# Venice Neighborhood Council

### STAFF REPORT

City Case No: DIR-2025-5042-CDP-ADJ-MEL-HCA

Address of Project: 635 E. California Ave. (Lot 21)

**B. Proposed Street Elevation with Fence:**

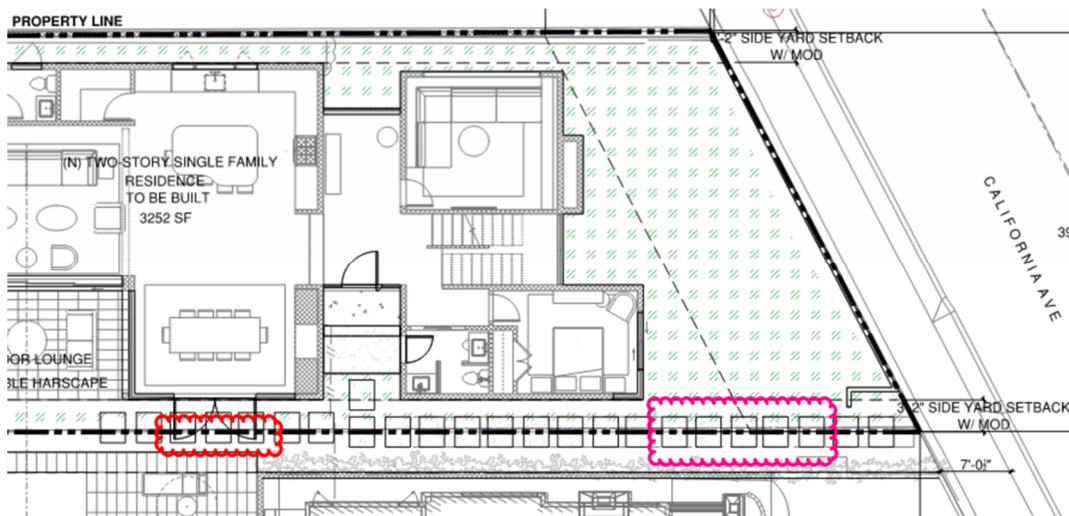
Primary street-facing elevation provided by Applicant and used on City's neighbor outreach notification does not depict side adjacent neighbor buildings nor accurately convey actual distance to side yard property lines.

Note side yards are depicted wider than actual.

**D.2 Site Plan:**

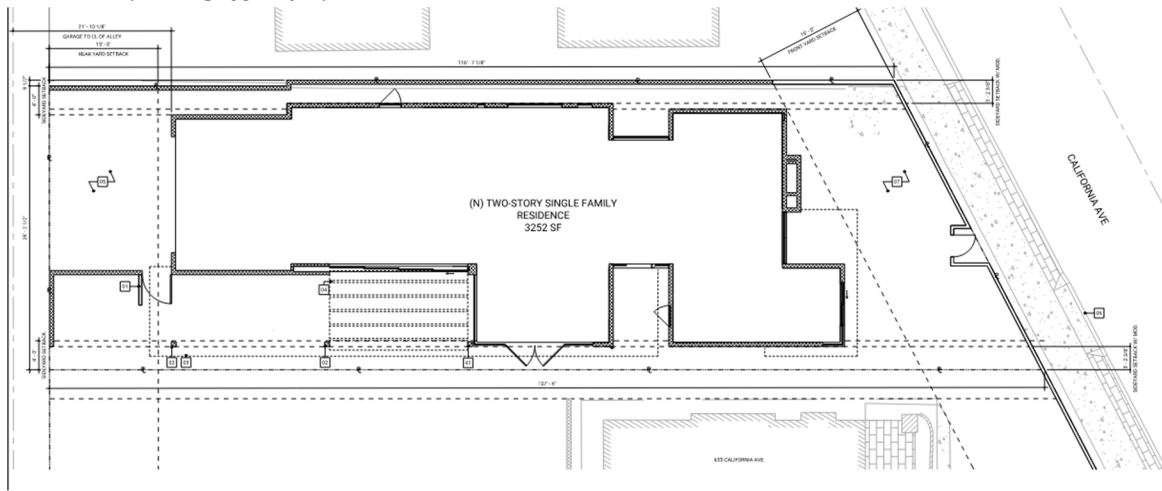
In Applicant's Findings, variance is necessitated due to "substandard" lot with varied width. LUPC is unclear to what "substandard" refers. Related to width, Applicant is revising Site Plan A1.101 wall depiction on Property's side of east property line to actual conditions with a small jog to match Pacific Land Consultant survey. According to Applicant, proposed wall on Property is 7" w. Thus, 3'-2.375" proposed side yard setback - 7" wall = 2'-7.375" clear. This width seems to be tight for firefighting; however, LUPC defers to LAFD for their approval or denial.

Applicant's setback diagrams do not address side yard dimensions at the north/alley of the Site. This clearance differs from dimensions cited at Site's south/street end. However, north/alley side yard setbacks appear to be either in compliance (at west) or no more out of compliance (at east) as what is dimensioned at the south/street end. Front and rear yard setbacks are compliant.

### D.3 Grund Floor Plan:

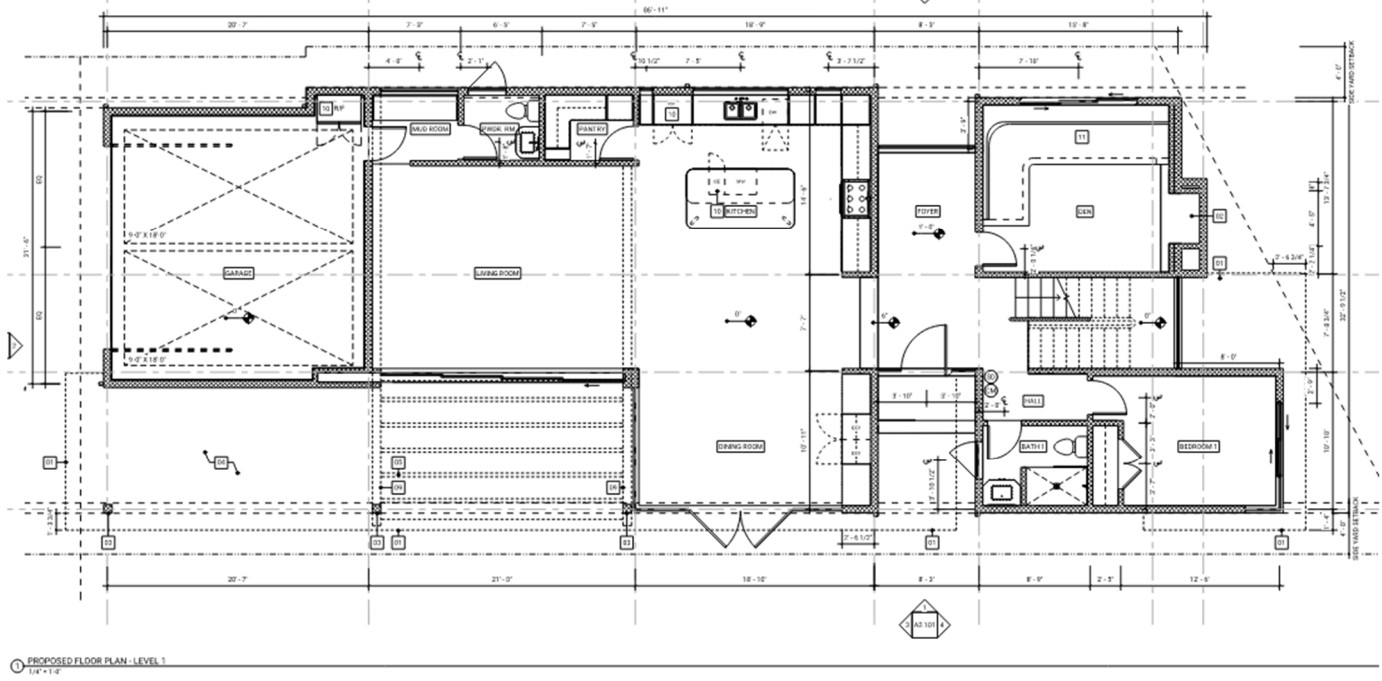
However, Owner definitely designed Lots 21 & 22 to flow together and Project's Landscape Plan L1.0 depicts a single line of pavers along on both sides of Lots' shared property line. (Refer to Exhibit D.1 circled **pink**.)

LUPC requested that Project's double swing doors opening over shared property line be moved to the north wall of that room or changed to sliding doors. (Refer to Exhibit D.1 circled **red**.)
